ITEM 9.3
1 KING STREET, CONCORD WEST - PROPONENT PLANNING PROPOSAL
Reporting Manager Manager Strategic Planning

To provide Council with the outcome of the assessment of a Planning Proposal relating to 1 King Street, Concord West and seek Council endorsement to submit the Planning Proposal to the Department of Planning and Environment (DPE) seeking a Gateway Determination.

Figure 14: PRCUTS Recommended Land Use Zone (Source: PRCUTS Planning and Design Guide)

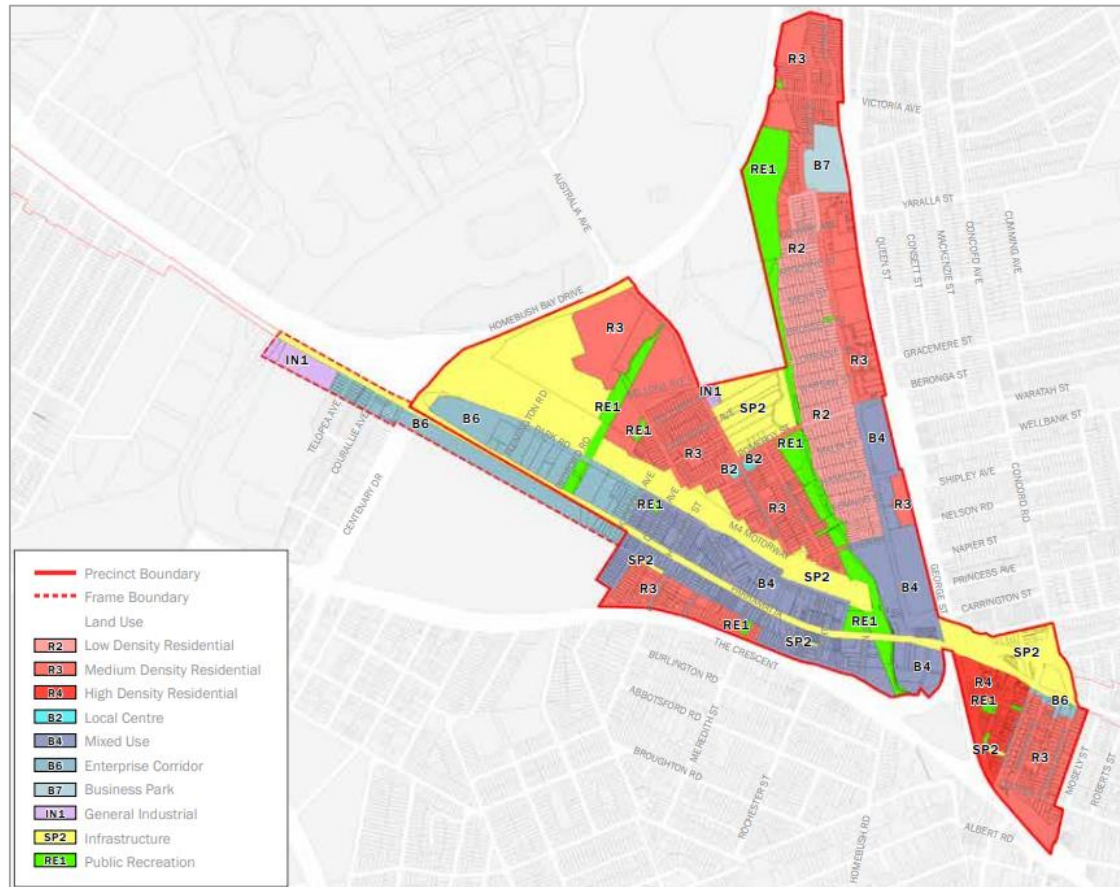
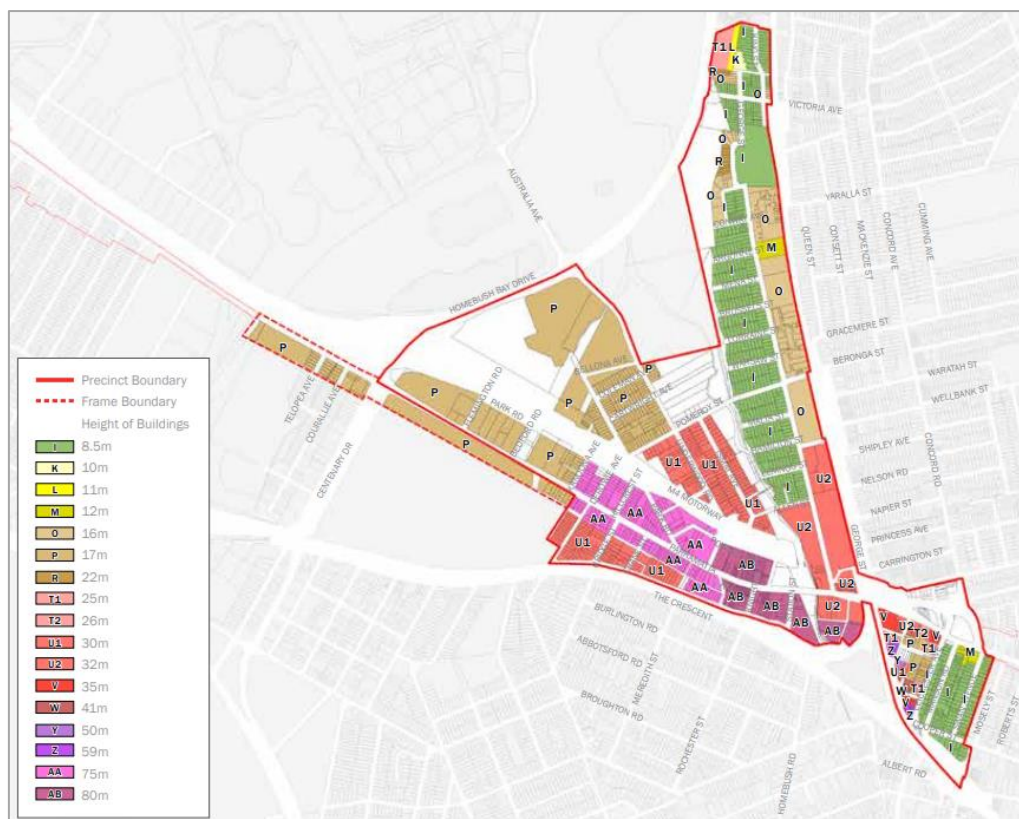
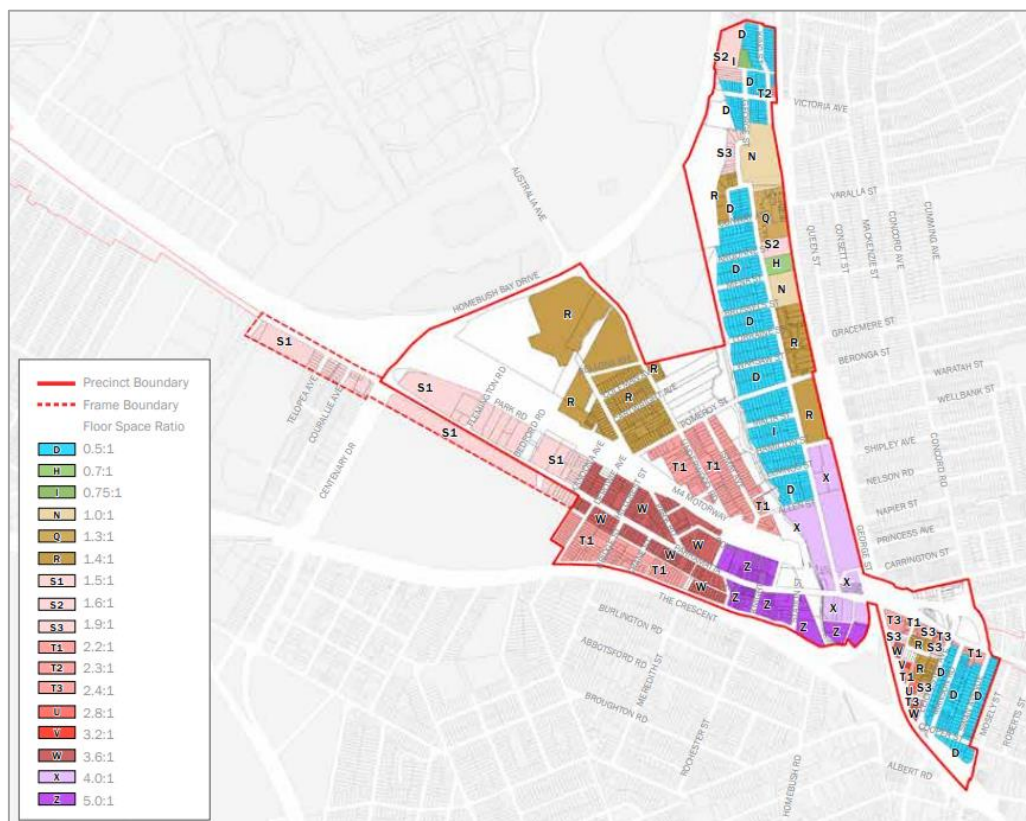
The 9.1 Local Planning Direction states that a planning proposal for the site should be consistent with PRCUTS unless a study is prepared to the satisfaction of the Planning Secretary *‘that clearly demonstrates better outcomes are delivered than identified in the Parramatta Road Corridor Urban Transformation Strategy and Parramatta Road Corridor Implementation Plan 2016-2023 having regard to the vision and objectives.’*

The Planning Proposal addresses the vision and objectives of PRCUTS and has submitted a Social Impact Assessment and an Economic Impact Assessment (at Attachment C), however these documents do not satisfy the requirement for a Study.

Figure 17: Preferred flood mitigation strategy – George Street (Source: Proponent)

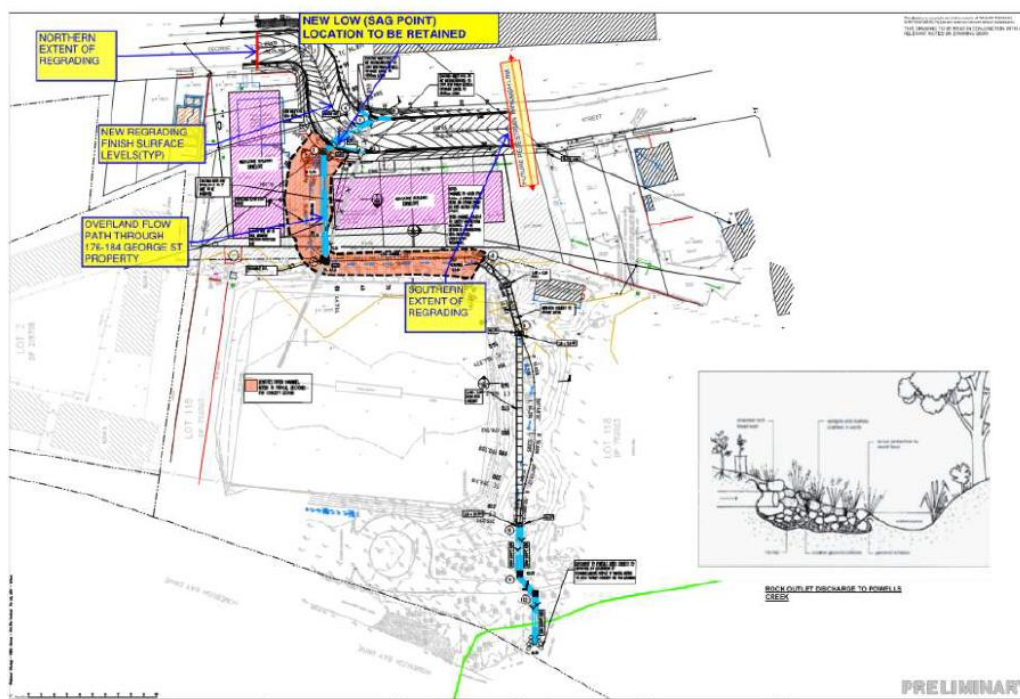
The 'George Street Sag', which is located at a low point, where George Street forms an 'S' bend opposite to 176-184 George Street, Concord West is within the Flood Planning Area. A mitigation strategy has been prepared for the George Street sag point, which reduces depths of flooding for the 1% AEP event. The Strategy will require the road to be raised by approximately 2.0 metres to enable stormwater to be discharge through a proposed easement over 176-184 George Street, Concord West into Powell's Creek.

Council proposes to progress the preparation of a detailed design for the mitigation works to the George Street Sag given the impending development at 176-184 George Street and a possible development on the subject site.

Prior to the Planning Proposal being submitted to the Department of Planning and Environment for a Gateway Determination, the flood assessment prepared on behalf of the applicant should be updated to consider the preferred mitigation strategy for George Street and demonstrate consistency with the 9.1 Direction for Flooding.

Figure 23: 3D visual comparison between the height of buildings shown in the illustrative masterplan (in blue) compared to the max HOB proposed in the Planning Proposal (shown in purple) (Source: Studio GL)

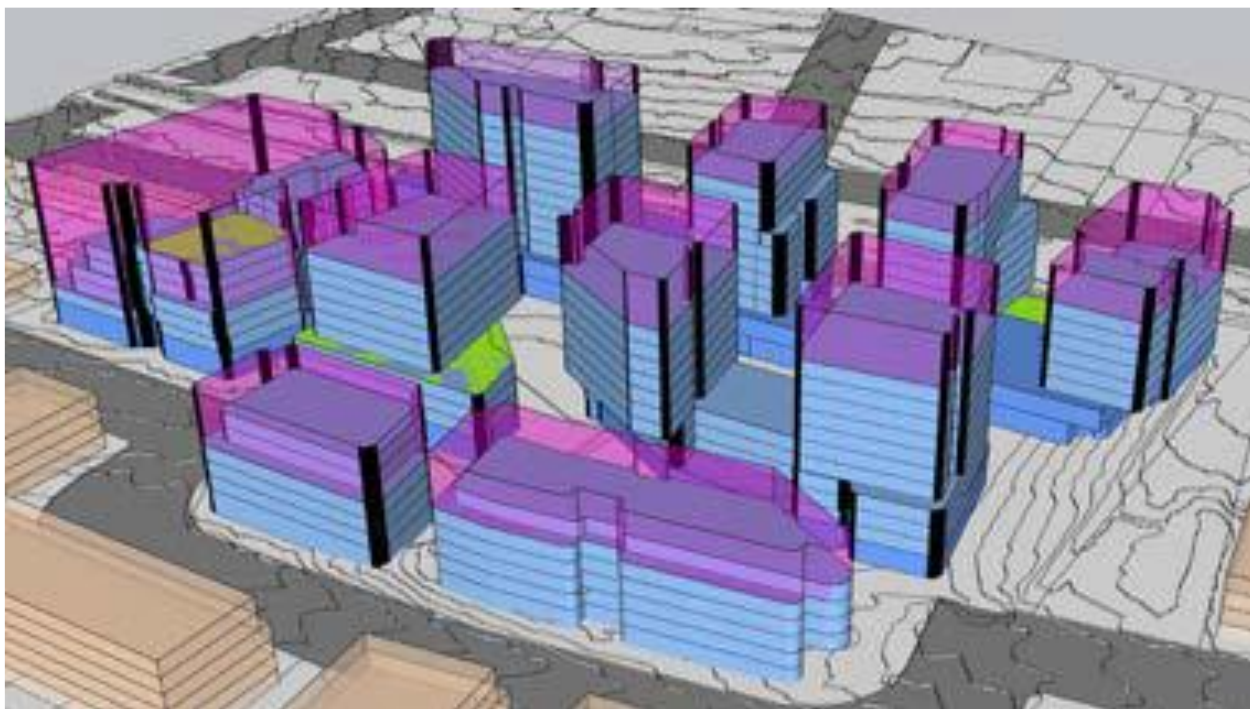
The Planning Proposal seeks to amend the maximum height of building standard to permit building heights that are significantly higher than shown in the supporting indicative master plan. This is problematic as the scale of development shown in the indicative masterplan is less than what could

occur should the LEP be amended as per the Planning Proposal. This could result in the extent of overshadowing being greater than shown in the shadow analysis, and the scale of future development being greater than shown in the visual impact assessment, which are based on the indicative masterplan not the LEP heights.

Figure 29: Recommended Floor Space Ratio (Source: Council mapping)

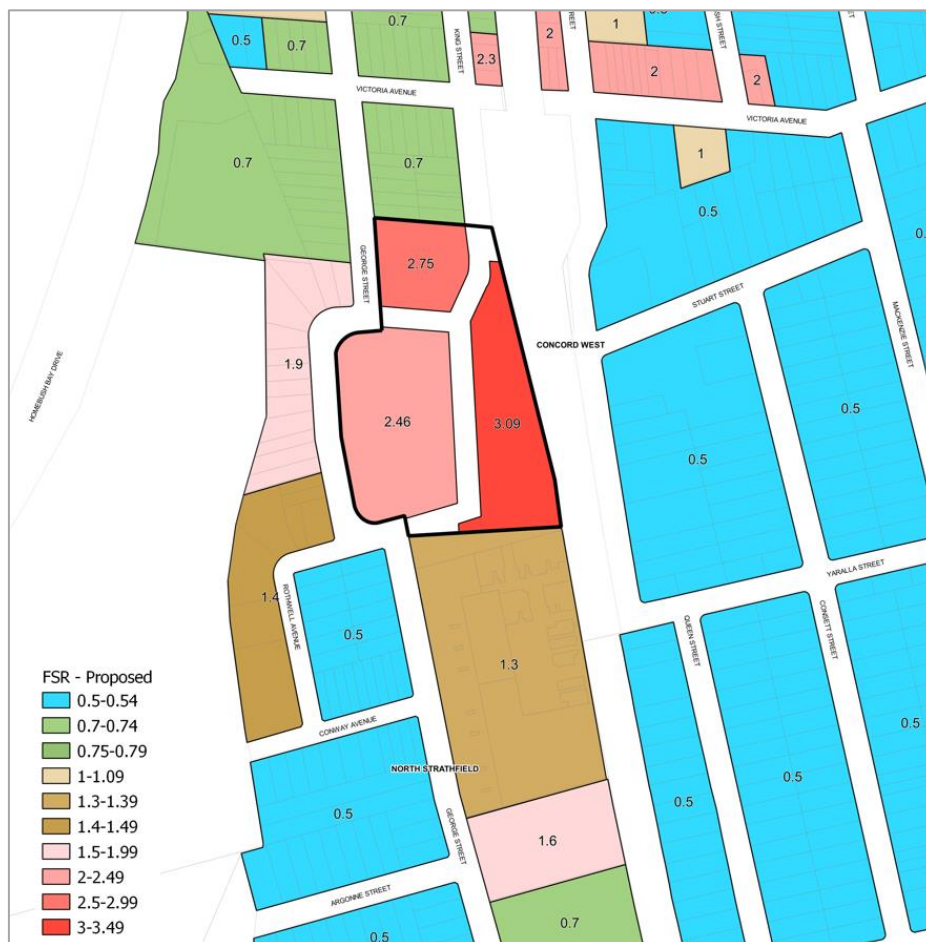
Council's independent urban design consultant has recommended a range of changes to the submitted illustrative masterplan that modifies building heights and alters the building envelopes in accordance with the *Apartment Design Guide*. The revised scheme achieves a Gross FSR of 2.23:1. For comparison, the Ashmore Precinct in Erskineville has a Gross FSR of between 1.0:1 and 1.25, Harold Park a Gross FSR of 1.15:1 and the recently rezoned Bushells site, a Gross FSR of 1.25:1.

- a local clause be included within the Planning Proposal that requires non-residential Gross Floor Area to comprise a minimum of 3,500m² and a maximum of 5,000m².
- deletion of proposed clause regarding the exclusion of enclosed balconies from Gross Floor Area.
- a maximum FSR of 2.23:1 be progressed for the Site with FSR standards being imposed on a block by block basis as illustrated in Figure 29 and at Attachment X.

Figure 30: George/Pomeroy Street layout – existing and proposed upgrade (Source: PWC)

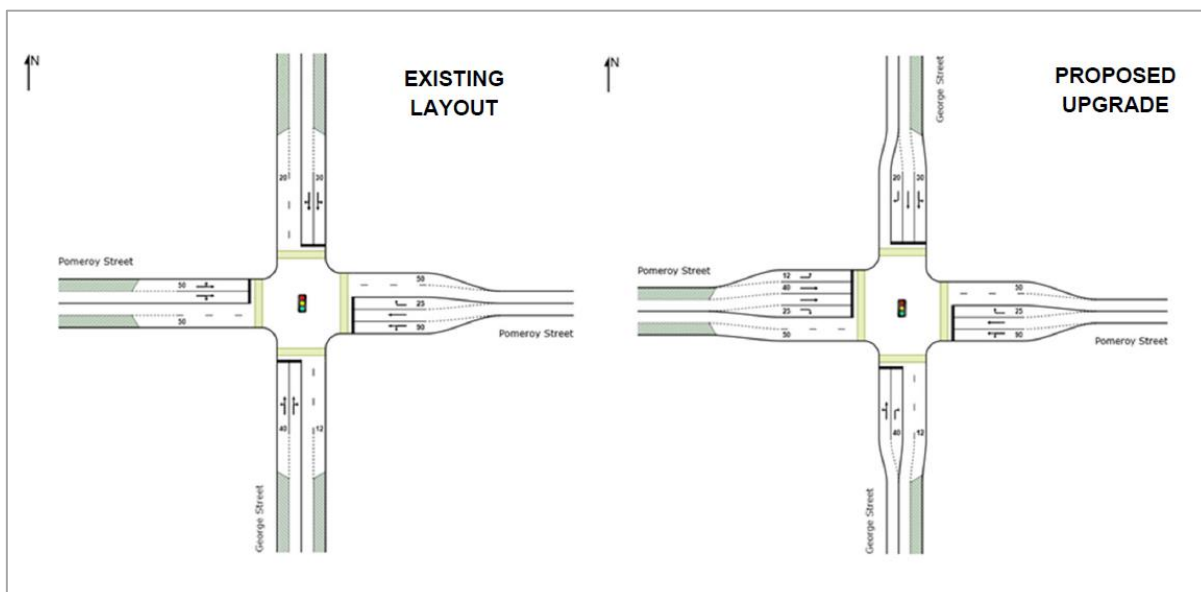
The Planning Proposal does propose to upgrade the intersection of George and Pomeroy Streets by providing additional capacity at the western and northern approaches, including:

Based on modelling outputs, the upgraded intersection is anticipated to operate with a Level of Service of 'C', representing an improvement over existing conditions.

Figure 31: Aerial photograph identifying 88 George Street, North Strathfield (Source: Council mapping)

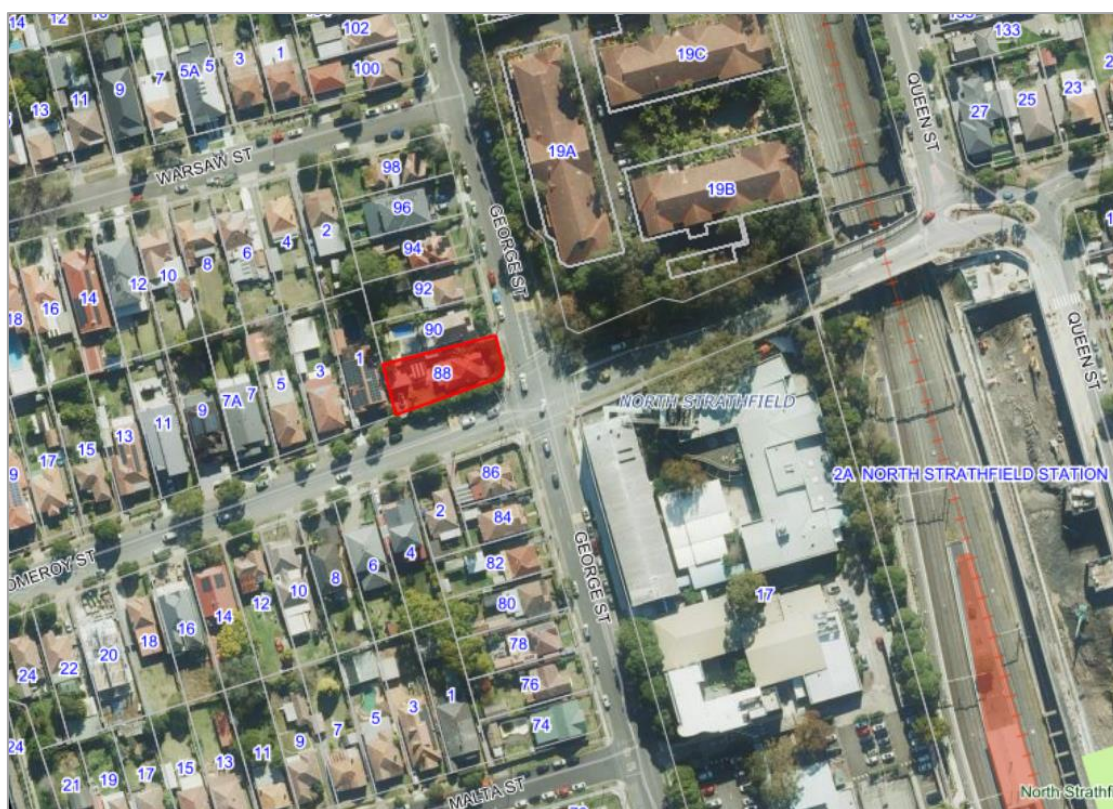
The upgrade of the intersection relies on the applicant having ownership or control of the land known as 88 George Street, North Strathfield (Lot 92 DP 651651) (see Figure 31 below). As this land is not within the ownership of the applicant, the upgrade is not able to be realised through the planning proposal or the associated 'letter of offer' to enter into a planning agreement.

Figure 32: Alternative George/Pomeroy Intersection Design (Source: Council concept)

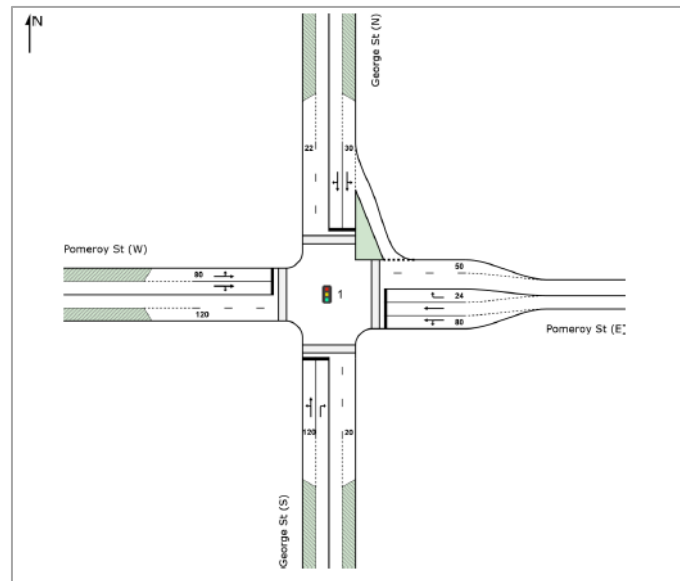
An alternative concept to upgrade the intersection has already been prepared by Council, predating the planning proposal. The main element of the upgrade is the provision of a left turn slip lane from George Street (north approach) to Pomeroy Street (east approach). Council is currently preparing a

The above design requires land (30.5m²) to be acquired from the property to the immediate east of the intersection (known as Strathaven at 19-21 George Street, North Strathfield or SP 50454). Any such acquisition would need to be identified on the Land Reservation Acquisition Map under the *Canada Bay Local Environmental Plan 2013*.

As the intersection upgrade is required to service the traffic generated by development arising from the planning proposal, it is recommended that the proposal does not proceed to a Gateway Determination until there is sufficient certainty that arrangements will be in place for the works to be funded. An update to the works schedule of the *Canada Bay Local Infrastructure Contribution Plan* is proposed to enable future development, the subject of the plan, to make a proportional contribution towards the intersection upgrade.
